Fishermans Bend Standing Advisory Committee – Tranche 3 Report

**Draft Port Phillip Planning Scheme Amendment C176port
2-28 Montague Street and 80 Munro Street, South
Melbourne**

3 July 2020

Fishermans Bend Standing Advisory Committee Tranche 3 report under section 151 of the Act

Figure 5 The first 20 metres – activated public realm³⁸

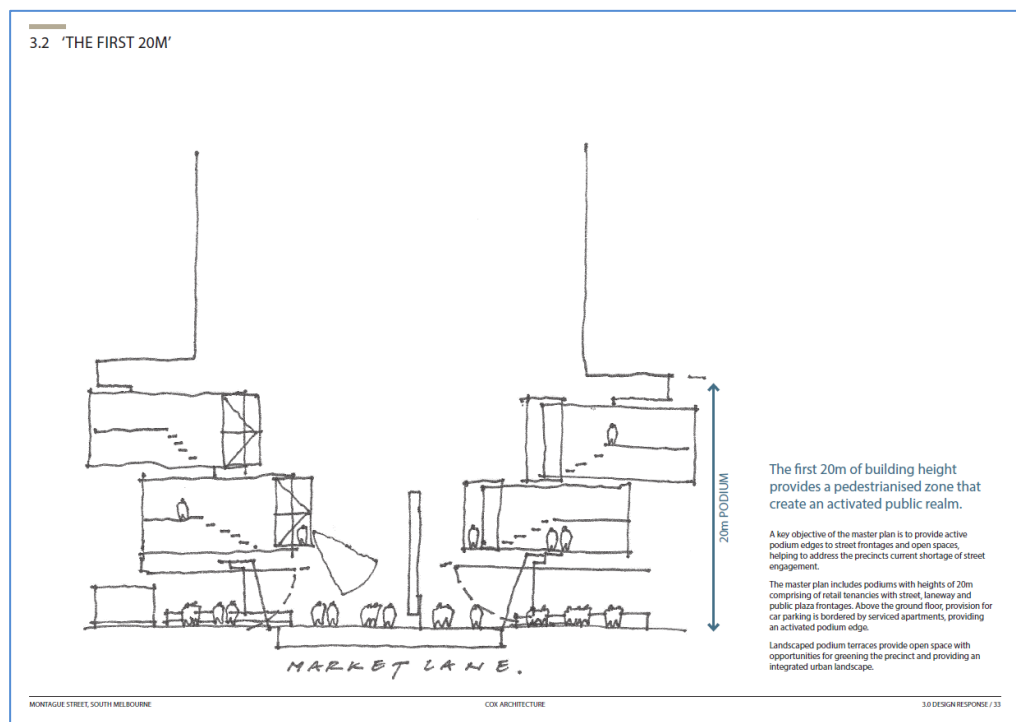
The plans show active frontages at pedestrian level. The Committee observes that the architectural concept section shown in Figure 5 suggests formal interest, vertical

This concept proves the laneway width can compensate for a reduced podium setback, however, the Committee observes that it is disappointing that the design sensibility of the sketch concept is not to be found in the Amended Masterplan Section 03 (Figure 6).

Figure 6 Tower 3 and Tower 2 Lobby Section 03 (annotations by Committee)³⁹

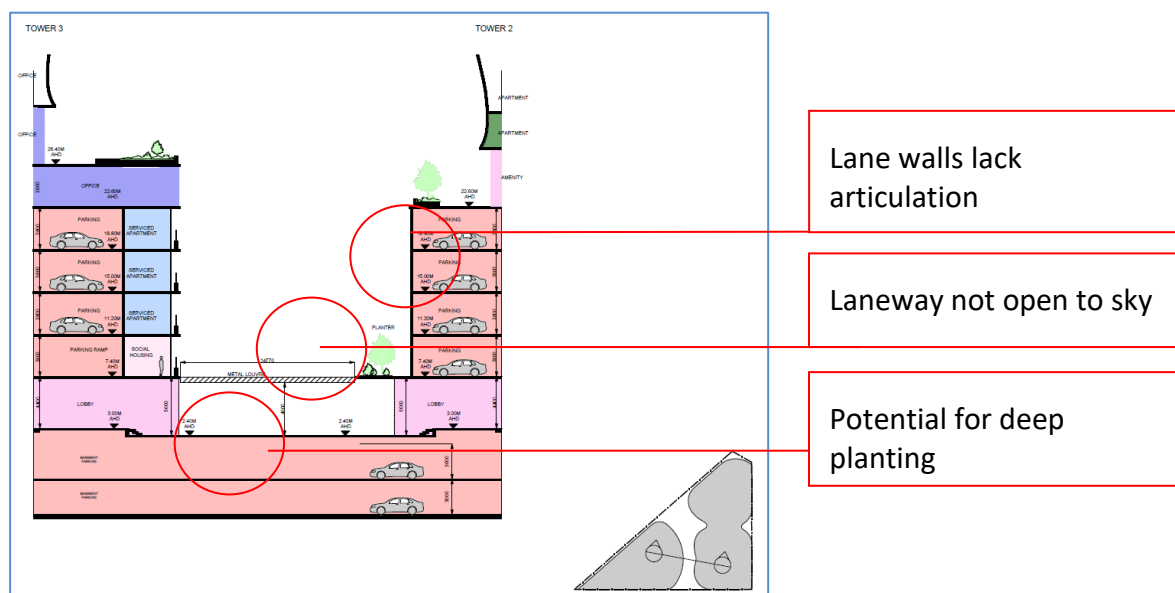
The public realm and laneway between Towers 2 and 3 is suitable in width but is not open to the sky – a horizontal louvre screen over effectively encloses it. In the Committee's view, this design approach is not consistent with the built form outcomes included in DDO30, which require laneways to be open to the sky and to accommodate deep planting. It also erodes the potential casual surveillance over the laneway as suggested by the design response sketch.

Consistent with the Committee's observations above in relation to the opportunities to provide for deep soil planting, Section 03 (Figure 6) highlights the capacity to find space for deep planting under the laneway. As discussed in section 4.2 of this Report, car parking is proposed in excess of the planning scheme requirements; an approach the Committee is not supporting. The Committee is of the view that reducing car park provision could facilitate this improvement to the public realm. The Committee also considers that a more nuanced approach to wind amelioration is required in lieu of the horizontal metal louvre screen.

Generally, the Munro Street laneway provides good north-south connectivity through the large block. The Committee considers the reduced podium setback is acceptable if the design quality of the lane is refined to better meet the ambitions for a laneway. This includes providing active and engaging frontages, being open to the sky and allowing for canopy tree planting.

Figure 7 North East (Montague Street) elevation⁴⁰

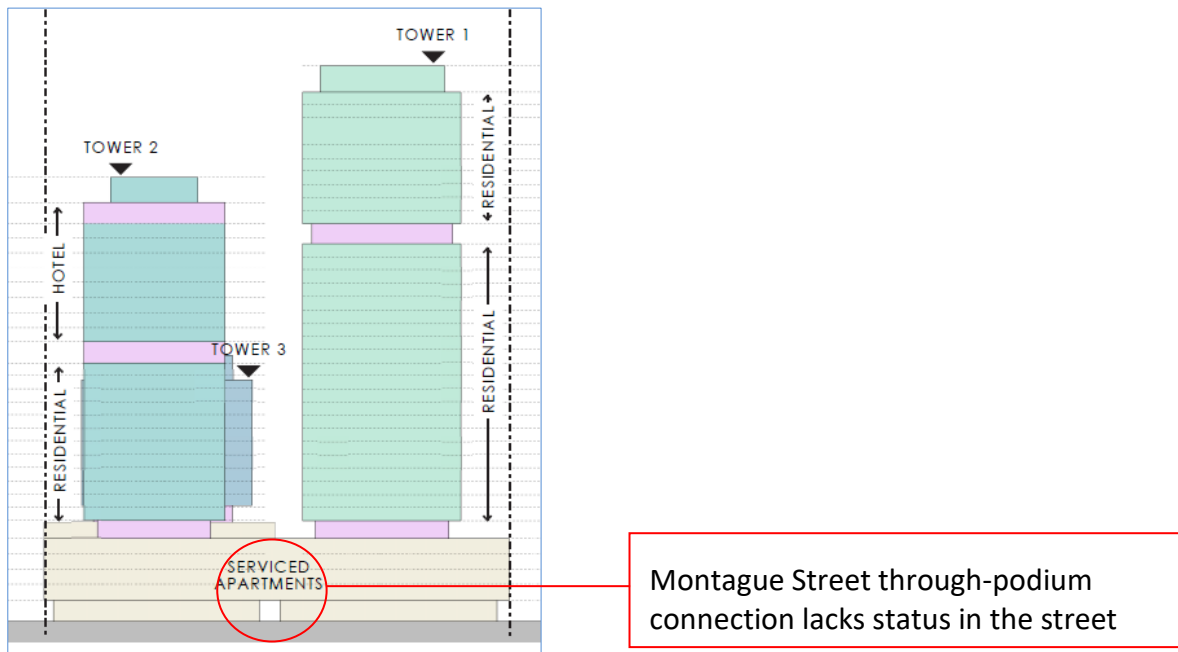
Clarity will be needed on how public and private access will work in this through-podium connection. Spatial quality, lighting and finish need to be understood – it must be a safe, attractive and appropriately scaled link to Montague Street. Within the Master Plan there is limited detail on materials, grain and scale and the quality of the arcade experience needs to be detailed. The ceiling/soffit is low and the entry has little urban presence on Montague Street (Figure 7).
